Comments on NYM/2019/0154EN/OHL - Case Officer Mrs H Saunders - Received from Mrs Alison Atkinson at Loftus Town Council, Loftus Town Hall, High St, Loftus, TS13 4HG Subject:

NYM/2019/0154EN/OHL

Subject: 279547 (03) Rebuilding of overhead line (North York Moors NP) NYM/2019/0154EN/OHL

Subject: NYM/2019/0154EN/OHL Northern PowerGrid OHL replacement archaeological constraints

Stubdale to Low Waupley Map

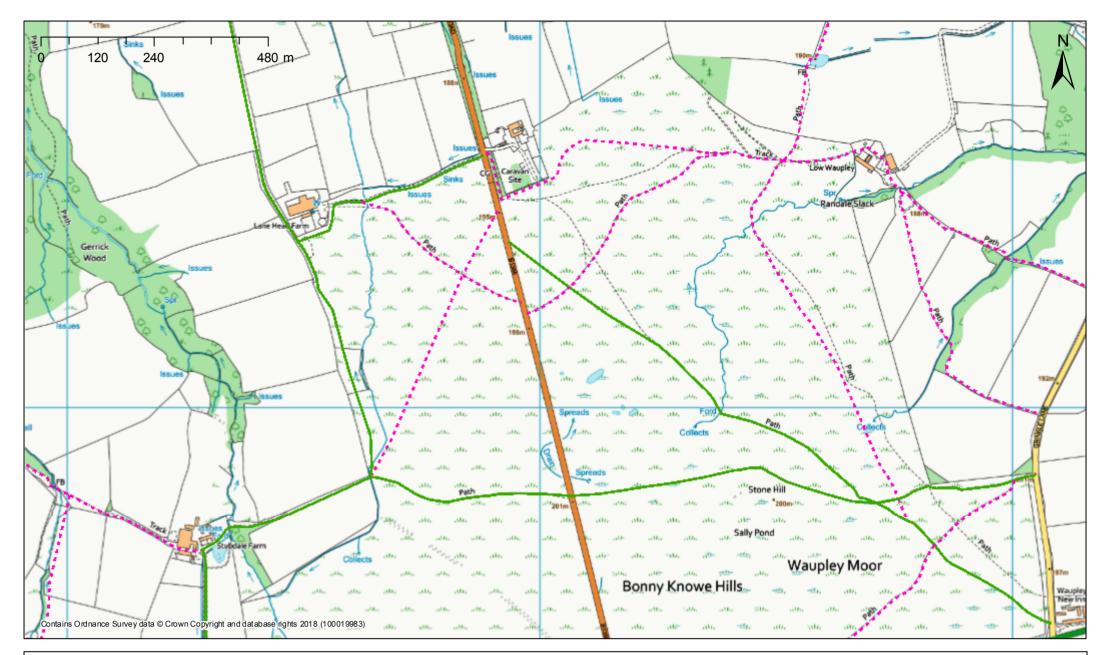
The route of the electricity line crosses several public rights of way as shown on the attached map. There must be no unauthorised interference with the use of these PROWs during the course of the works. We must be informed in advance of any works that will affect the use of any PROW so that appropriate steps can be put in place to organise temporary diversion routes.
